**LAKE GERALDINE DAM
DAM SAFETY INSPECTION 2023 #4
IQUALUIT, NUNAVUT**

PRODUCED FOR: THE CITY OF IQUALUIT
C/O COLLIERS PROJECT LEADERS

PRODUCED BY: CONCENTRIC ASSOCIATES INTERNATIONAL INCORPORATED

DATE: OCTOBER 4TH, 2023

Site Plan – South Berm

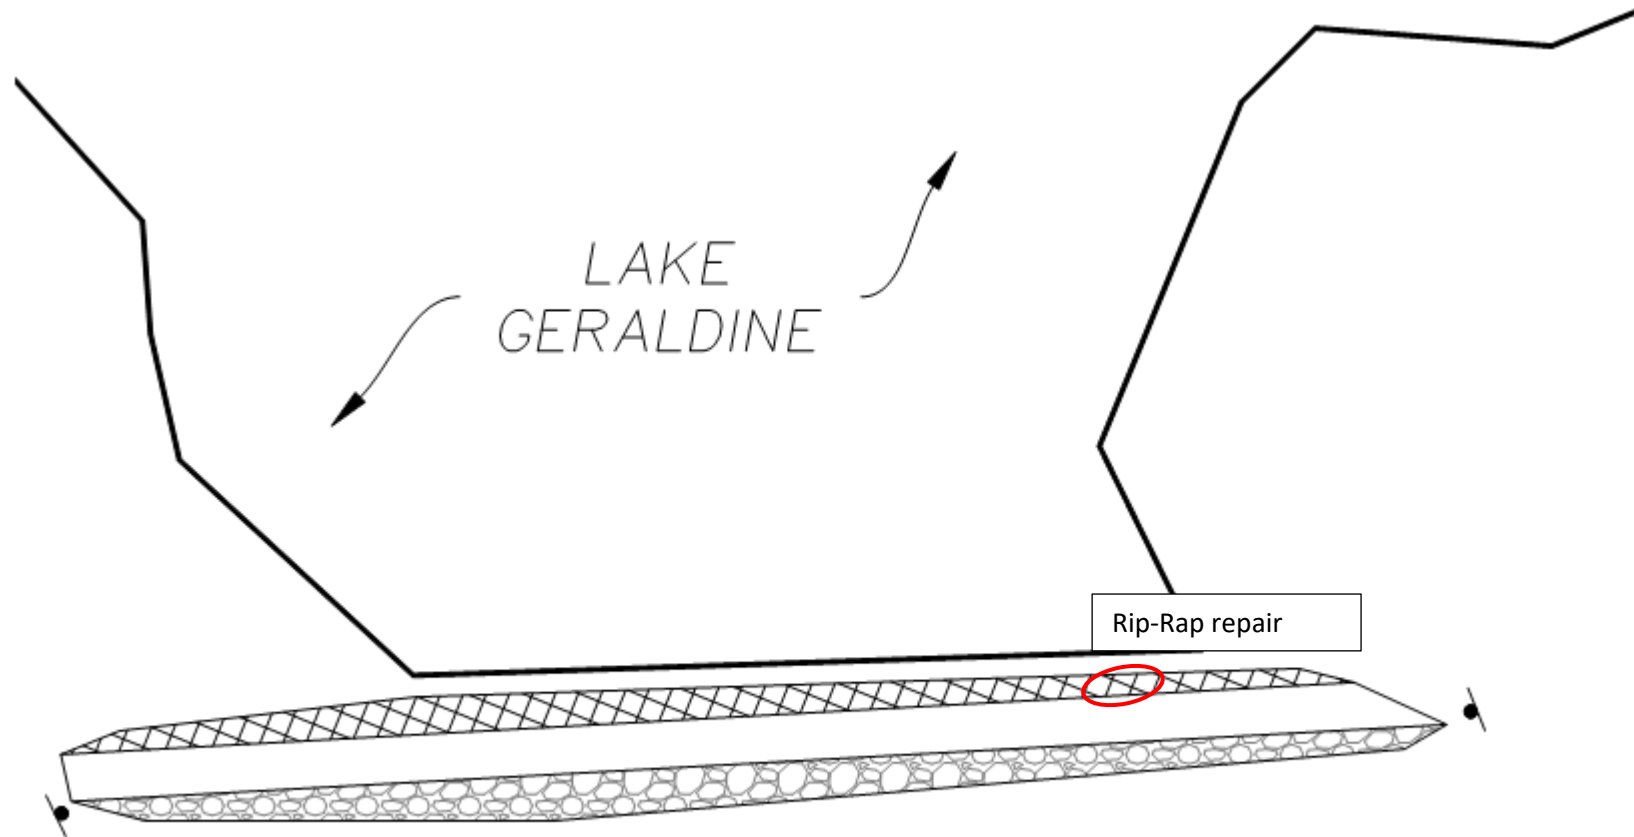
Description	Yes	No	Observations	Action Required
Displaced rip-rap /armor stone on the upstream face of berm		X		
Displaced rip-rap /armor stone on the downstream face of berm		X		
Transverse / longitudinal cracking, within the Top / crest of the berm (Indicate if new, existing, expanded, length, width)		X		
Transverse / longitudinal cracking, within the Upstream face of the berm (Indicate if new, existing, expanded, length, width)		X		
Transverse / longitudinal cracking, within the Downstream face of the berm (Indicate if new, existing, expanded, length, width)		X		
Wet area or active leakage / seepage within the downstream side face of berm Is there silt / sand within the leaking water		X		
Ponding water at base of the berm (downstream), is there sand or silt suspended within the water		X		
Additional Comments, Sketches or Observations VOC soil contamination at base of power pole not remediated.

Elevation – Downstream Face, Concrete Dam and Spillway

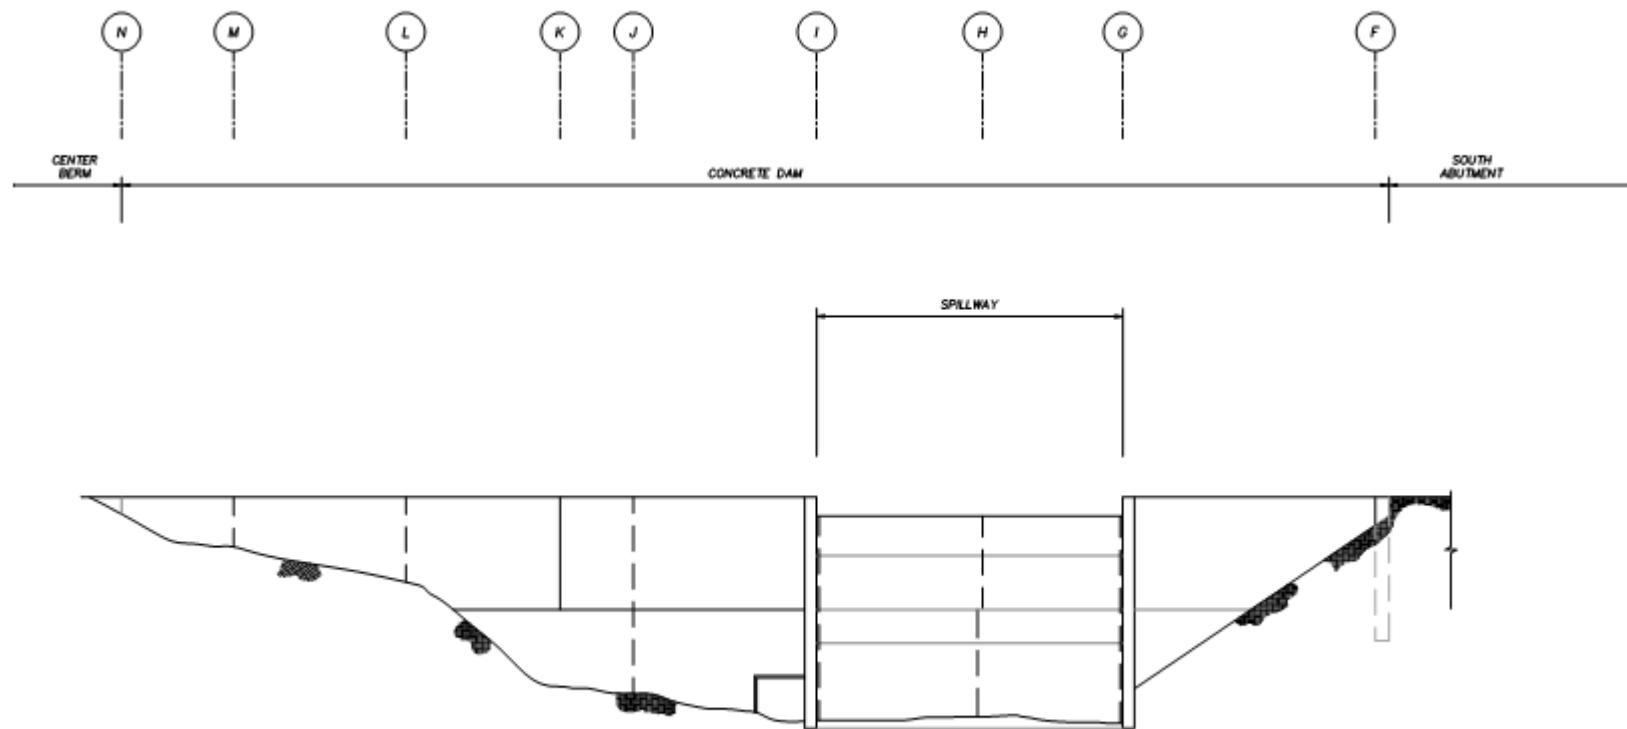
Sealant Condition – Top of Dam			In poor condition, ravens have picked out a large amount of material from the joints	X
Sealant Condition – Up stream face of Dam			No change	
Sealant Condition – Downstream face of Dam			Minor (typical) leakage at base of dam	
Active seepage / leakage at: - Interface between concrete and ground (bedrock) - Sealant joints	X		Minor (typical) seepage at interface between the concrete dam and the bed rock.
